DART AEROSPACE LTD		Work Order: 120869
Description: Crosstube Assembly		Part Number: D407-667-145
Inspection Dwg: D407-667-145 Rev: C		Page 1 of 2

DRAWING NO. D407-667-145	TITLE CROSSTUBE ASS'Y (407 HIGH FWD)	REV. C	DART AEROSPACE LTD ENGINEERING ORDER		D.E.O. NO. D407-667-145-C-1	SHEET NO. SHEET 1 OF 1	SCALE NTS
DRAWN <i>47</i>	CHECKED <i>ASS</i>	MFG. APPR. <i>18</i>	APPROVED <i>WD</i>		DE APPR. <i>#</i>		
DATE 11.07.15	DATE 11.07.22	DATE 11.07.22	DATE 11/07/22		DATE 11.07.21

DRAWING NO. D407-667-145	TITLE CROSSTUBE ASS'Y (407 HIGH FWD)	REV. C	DART AEROSPACE LTD ENGINEERING ORDER	D.E.O. NO. D407-667-145-C-2	SHEET NO. SHEET 1 OF 1	SCALE NTS
DRAWN AJS	CHECKED	MFG. APPR. <i>E</i>	APPROVED <i>AD</i>	DE APPR. <i>[Signature]</i>		
DATE 12.08.02	DATE 12.08.02	DATE 12.08.02	DATE 12.08.02	DATE 12.08.02

C TURNING DETAIL

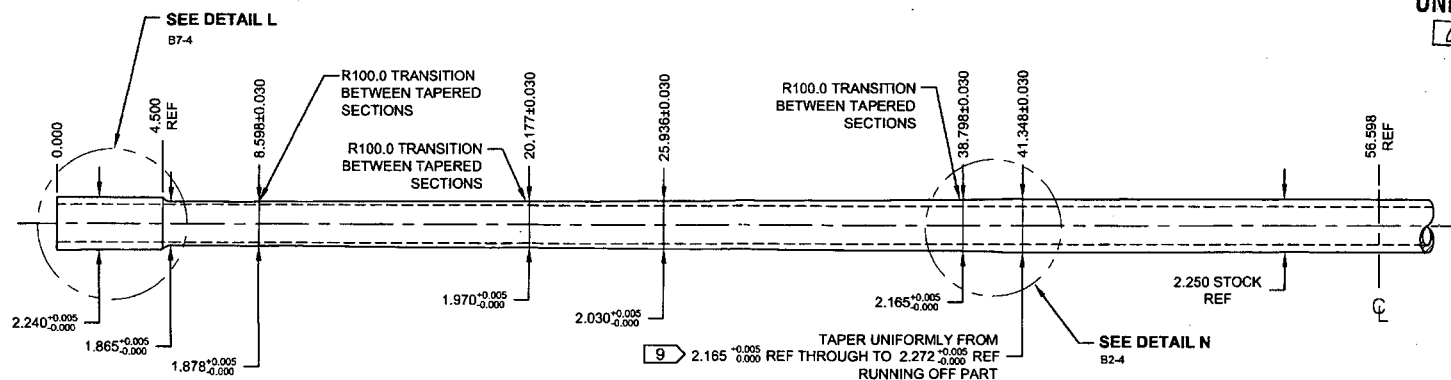
C	REVISE GENERAL NOTES/PART LIST (ZN D7-1); REORGANIZED VIEWS AND REFORMATTED DRAWING TO CURRENT STANDARDS. D3595-063-395 WAS D2856-400-694 (ZN D6-2 & A5-2); REMOVED REF. 7 ADD TOLERANCES (ZN C6-3, C4-3, D2-3); RELOCATED FLAG #6 (ZN A6-3) PER NCR 210; MOVED TURNING DETAIL & UPDATED TOLERANCE TO SHEET 4.	RF	08.11.06
B	ADD HOLES AND NUT PLATES FOR COMPATABILITY WITH BHT/AA SKUDTUBES	PH	05.07.26
A	NEW ISSUE	CP	02.05.08
REV.	DESCRIPTION	BY	DATE
DESIGN	RF	DART AEROSPACE LTD	
DRAWN	RF	HAWKESBURY, ONTARIO, CANADA	
CHECKED	RF	DRAWING NO.	REV. C
MFG. APPR.	RF	D407-667-145	SHEET 1 OF 4
APPROVED	RF	TITLE	SCALE
DE APPR.	RF	CROSSTUBE ASS'Y (407 HIGH FWD)	NTS
DATE	08.11.06	COPYRIGHT © 2002 BY DART AEROSPACE LTD THIS DOCUMENT IS PRIVATE AND CONFIDENTIAL AND IS SUPPLIED ON THE EXPRESS CONDITION THAT IT IS NOT TO BE USED FOR ANY PURPOSE OR COPIED OR COMMUNICATED TO ANY OTHER PERSON WITHOUT WRITTEN PERMISSION FROM DART AEROSPACE LTD.

DETAIL P
BONDING STRAP INSTALLATION 2 PL

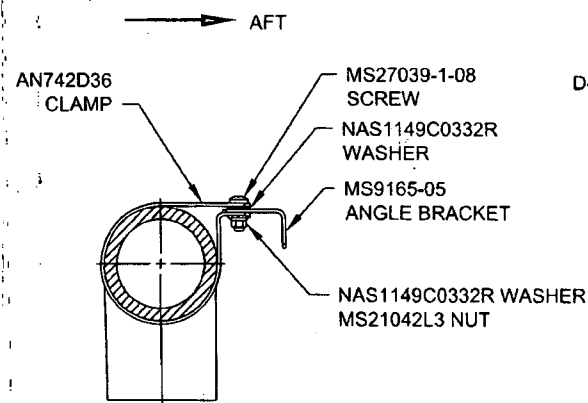
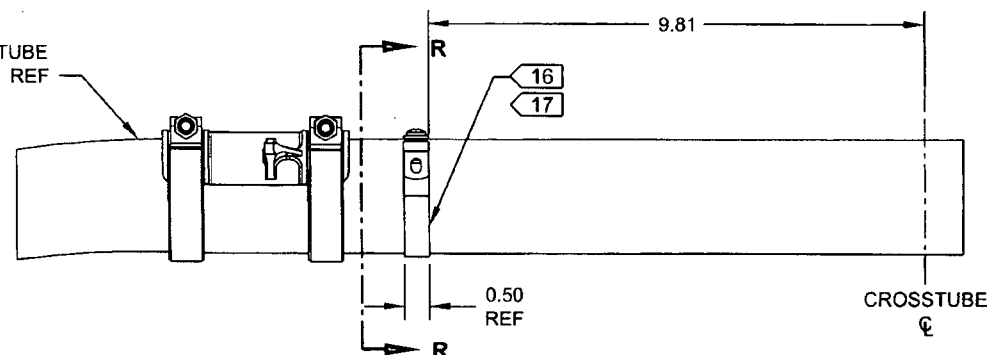
ADD ELECTRICAL GROUNDING STRAP

ITEM	QTY -145	PART NUMBER	DESCRIPTION
1	X	D407-667-145	CROSSTUBE ASSEMBLY (407 HIGH FWD)

10	2	AN742D36	CLAMP
11	2	MS9165-05	ANGLE BRACKET
12	2	MS21042L3	NUT (OR MS21042-3)
13	2	MS27039-1-08	SCREW
14	4	NAS1149C0332R	WASHER (OR AN960C10L)

- 16) MASK AREA UNDER CLAMP PRIOR TO PAINTING
- 17) SEAL EDGES WHERE AN742D36 CLAMP MEETS WITH THE CROSSTUBE USING SIKAFLEX-241/-291 OR MIL-S-8802 CLASS B2 OR PROSEAL 890 SEALANT
- 18) PERFORM RESISTANCE CHECK TO ENSURE MAX RESISTANCE IS 10 MILLIOHMS
